HORSESHOE LAKE 2ND ADDITION

Re: S/D 98-4 -- Final Plat of HORSESHOE LAKE 2ND ADDITION

At the regular meeting of the Subdivision Committee of the Metropolitan Area Planning Commission on Thursday, March 5, 1998, the above captioned plat was considered. The action of the Committee was to approve the final plat, subject to the following:

CASE NUMBER: S/D 98-4 - HORSESHOE LAKE 2ND ADDITION

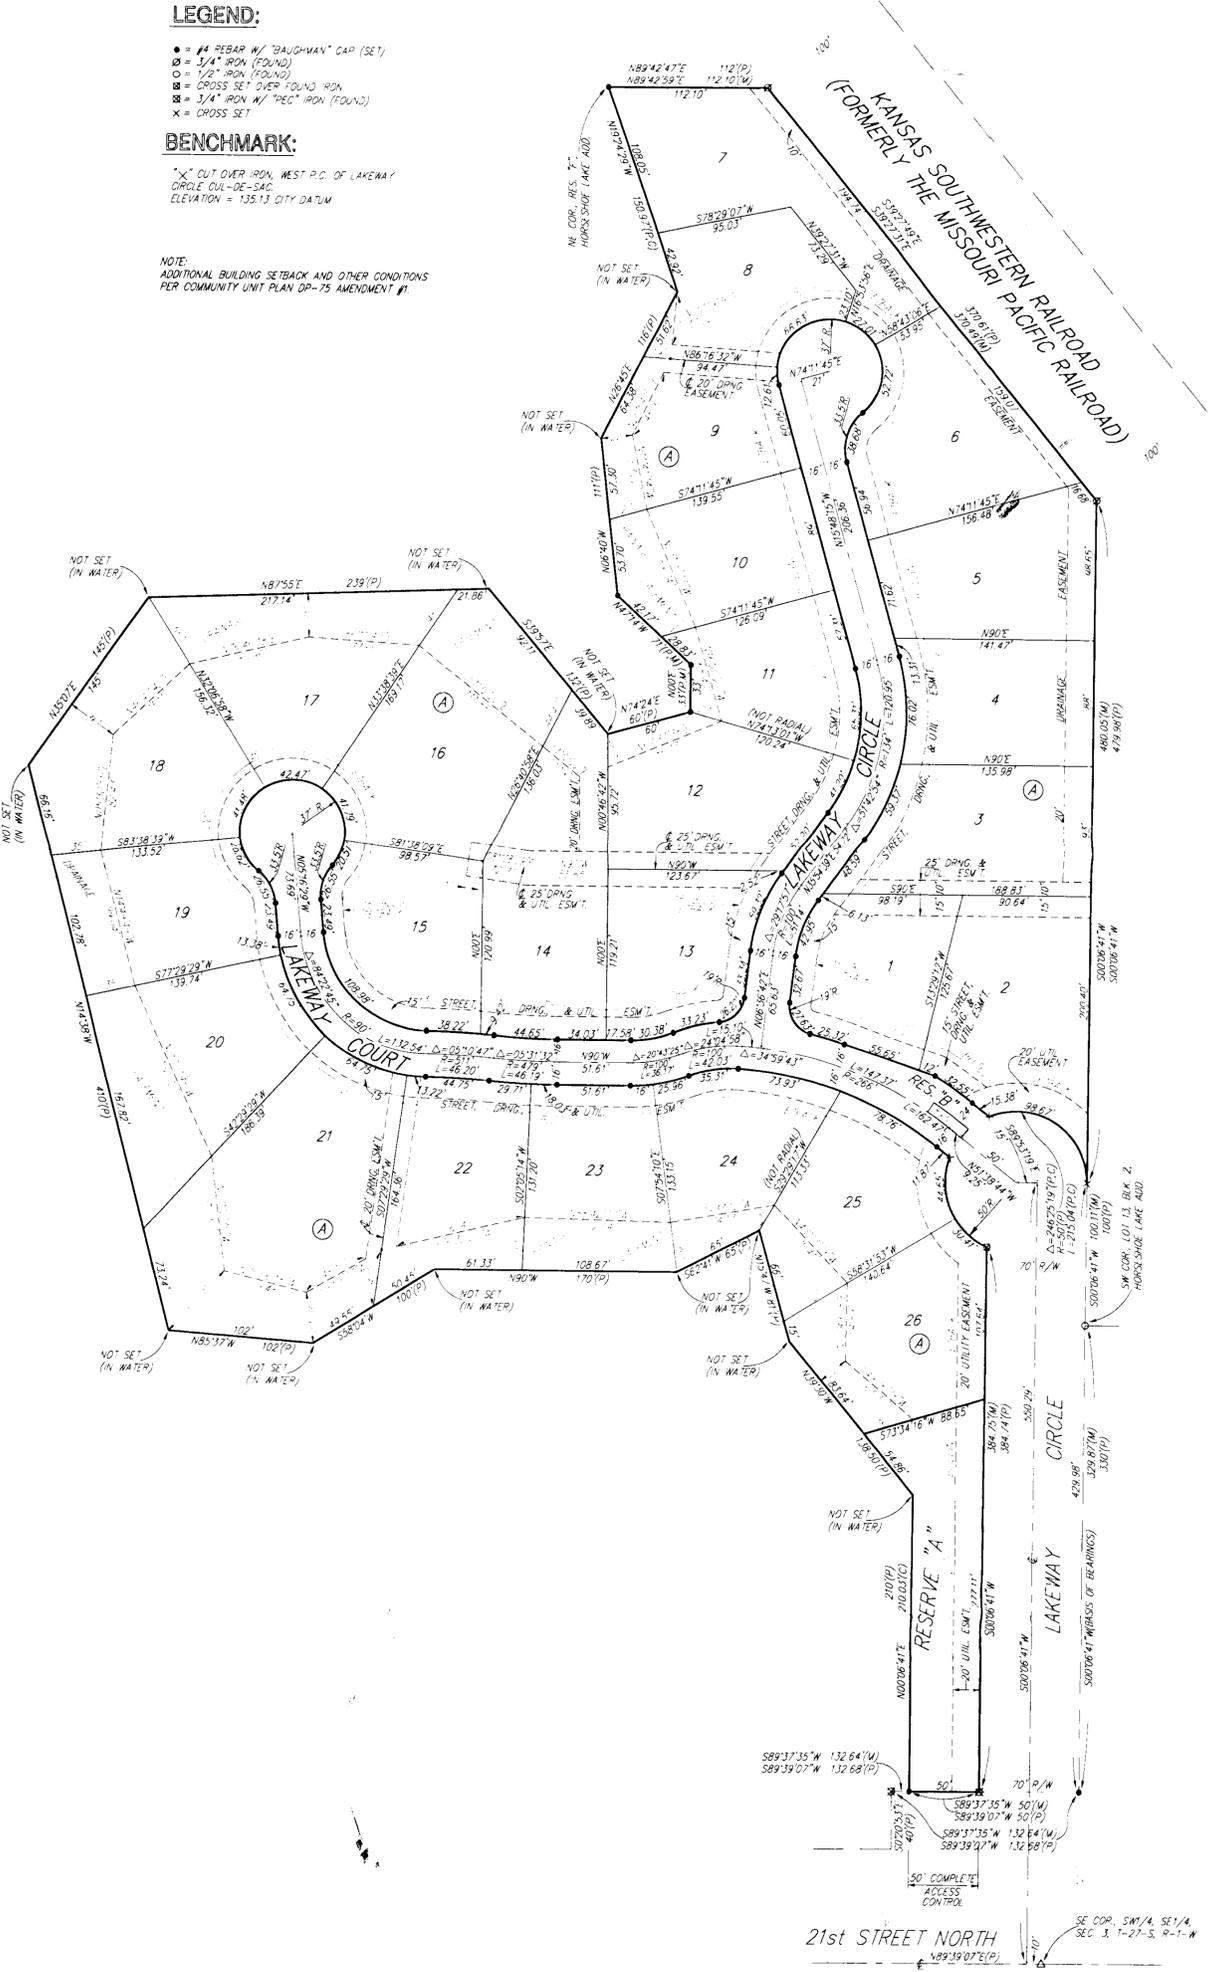
- A. **City Engineering** needs to indicate if guarantees are required for sanitary sewer or City water to serve this site. **City Engineering has requested that easements be increased to 25 feet when shared by sanitary sewer, storm sewer and other utilities.**

- C. **City Engineering** needs to comment on the status of the applicant's drainage plan. **The drainage plan is approved. Wherever storm sewer, sanitary sewer and other utilities share an easement, it is requested that the width of the easement be increased to 25 feet.**

- I. Traffic Engineering needs to comment on the need for any improvements to perimeter streets. Traffic Engineering has requested the elimination of the turnaround at the end of the existing street for safety reasons. Applicant desires to maintain the cul-de-sac to provide a separation between the commercial and residential uses.

- J. Fire Department needs to comment on the acceptability of the cul-de-sac access. Lakeway Court (approx. 650 feet) exceeds the maximum length of 600 feet as specified in the Subdivision regulations. The street length is acceptable due to topographical constraints.

- L. Fire Department needs to comment on the acceptability of the street names. The names of Lakeway Court and Lakeway Circle should be transposed. The final plat has denoted said revision.

- S. The representatives from the utility companies should be prepared to comment on the need for any additional utility easements to be platted on this property. *The representatives from Southwestern Bell and KGE have requested additional easements.* The easements have been denoted on the final plat.

- U. "Section 24" should be corrected to read "section 3" in the surveyor's certification.
- V. Unified maintenance of the adjoining lake in Reserve F of the Horseshoe Lake Addition should occur; consisting of homeowners in both Additions.

- X. On the final plat tracing, a note shall be placed on the face of the plat indicating that this Addition is subject to the conditions of Community Unit Plan DP-75 Amendment #1.

- The Subdivision Committee required the following: a) the existing turnaround be maintained, b) a 15-mph sign be posted 200-ft south of the existing cul-de-sac, c) A stop sign be posted at the existing cul-de-sac, d) A No Outlet sign be posted on 21st St., and e) A No Parking sign be posted within the existing cul-de-sac.
